Univent Replacement at Farley Elementary School
Univent Replacement at Willow Grove Elementary School
MSA File No. 42052

SED No. 50-02-01-06-0-003-011
SED No. 50-02-01-06-0-030-016

Re: ADDENDUM NO. 1

Drawing Title MECHANICAL DETAILS - 2
Drawing No. FES-M-502

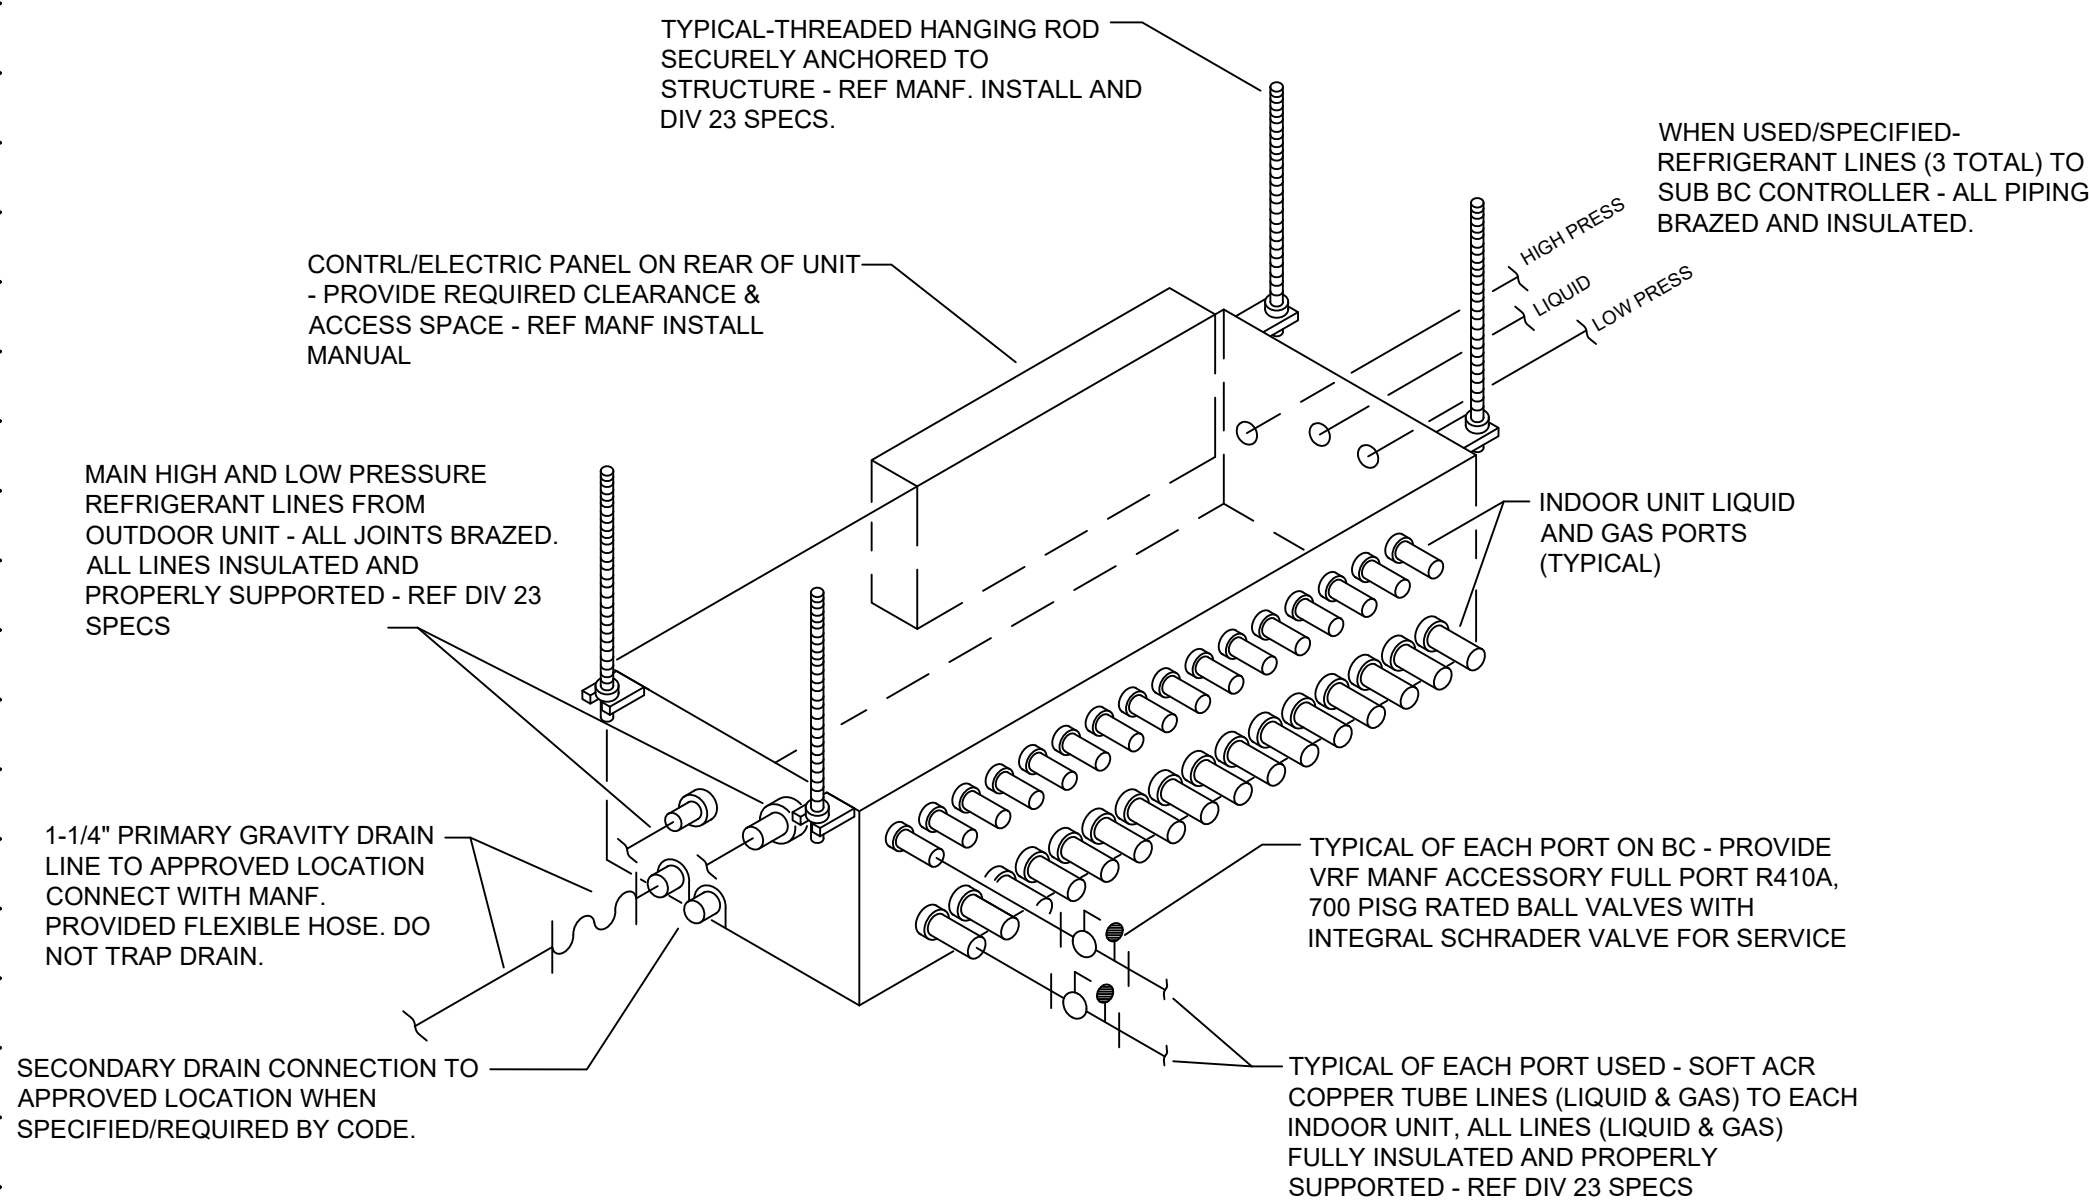
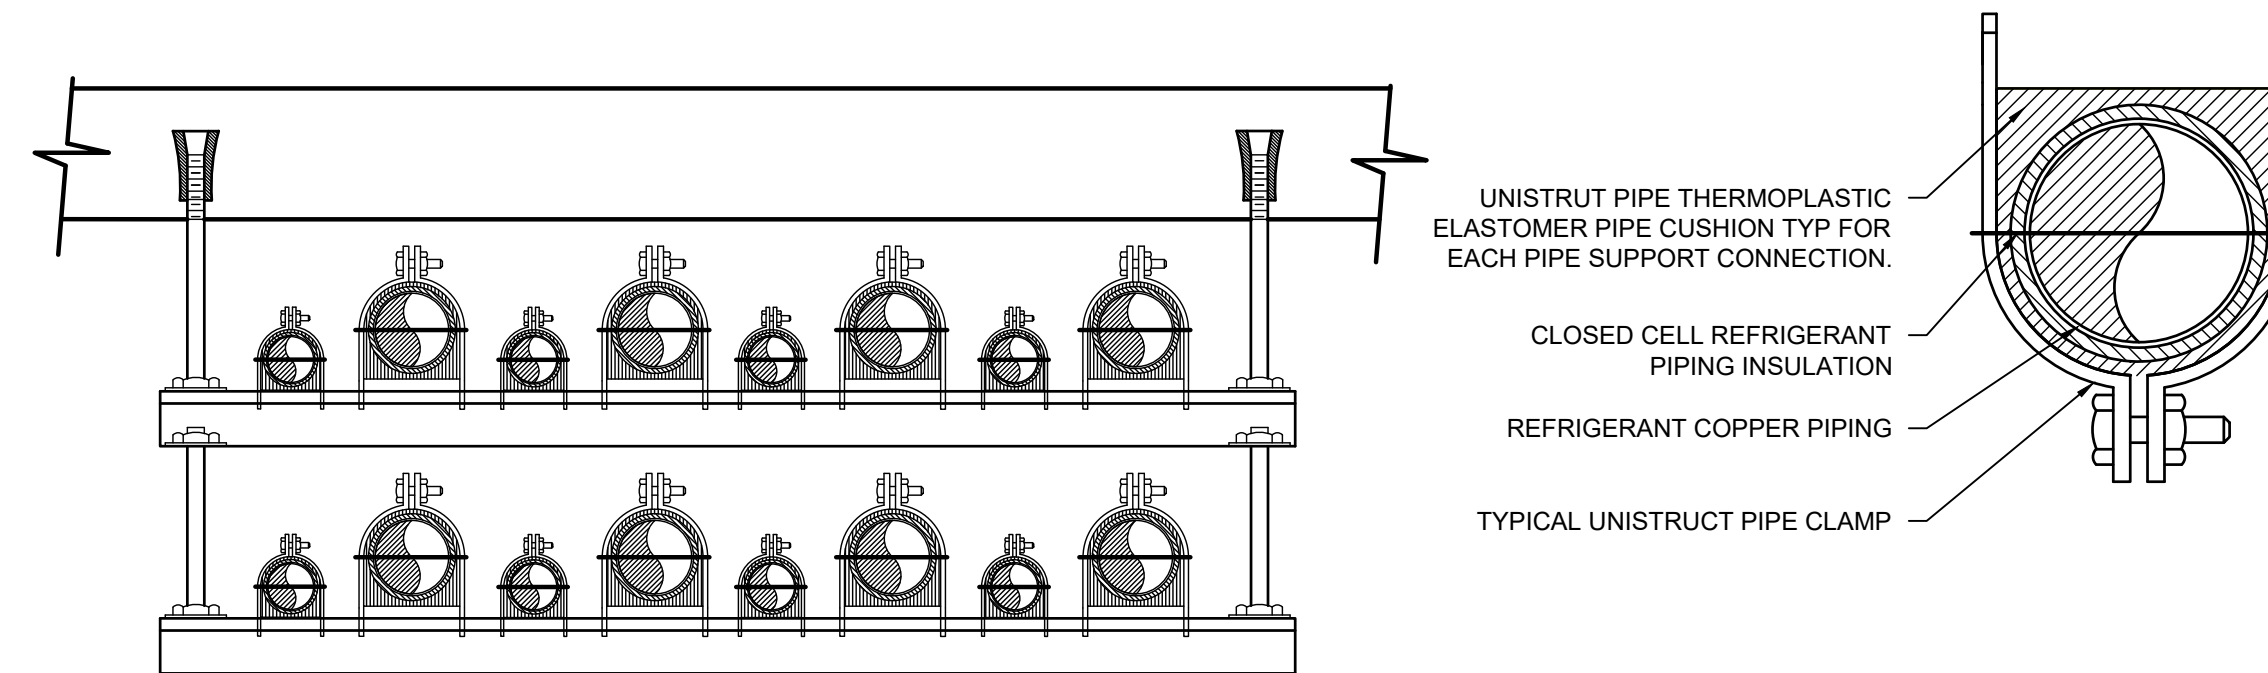
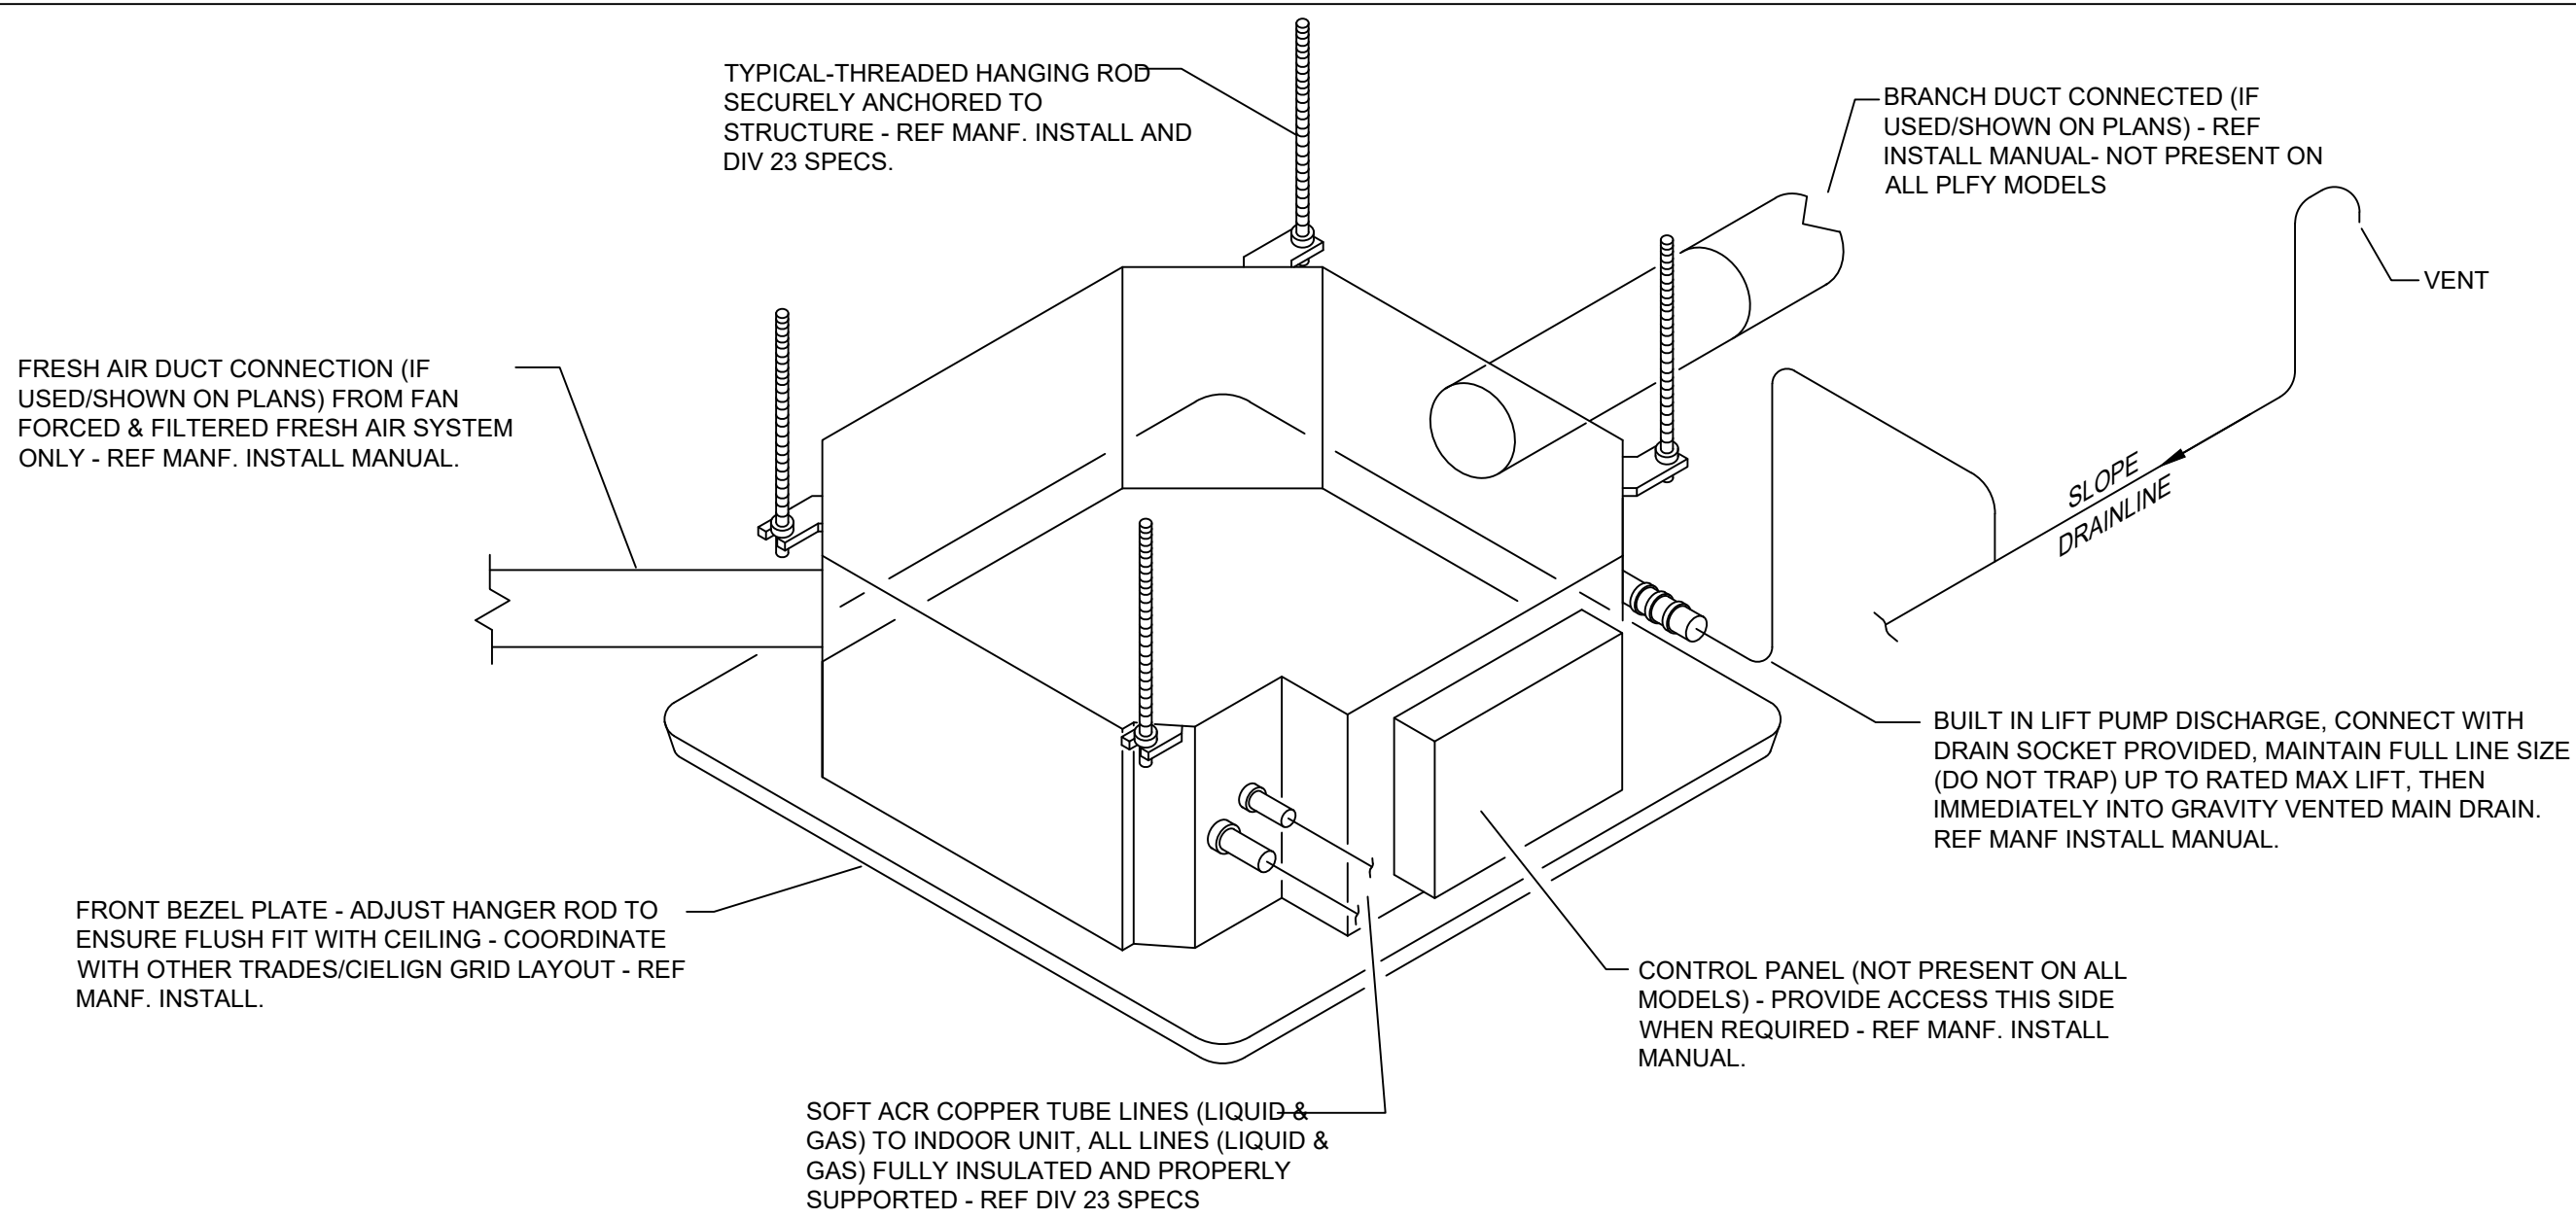
- 21) Drawing FES-M-105 has been revised dated, 11-09-23, see attached. Revisions include updates to Outdoor VRF Heat Recovery locations.
- 22) Drawing FES-M-502 has been revised dated, 11-09-23, see attached. Revisions include new details for rooftop condensate piping support and refrigerant piping detail.
